Technical Service BULLETIN

Title: 4RUNNER VSV TICKING NOISE

Models: '98 4Runner

ENGINE
EG007-99

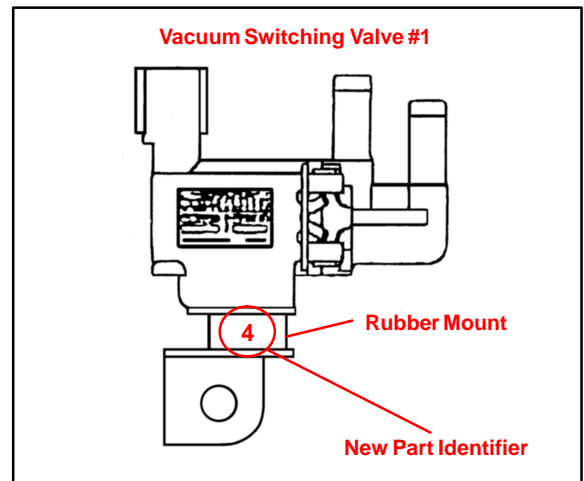
Introduction To eliminate a “ticking” noise in the cabin of the vehicle in cold temperatures (below 0° F), the hardness of the Vacuum Switching Valve Mount has been changed.

New parts can be identified by a “4” on the side of the rubber mount.

Replace VSV No. 1 with part manufactured after countermeasure.
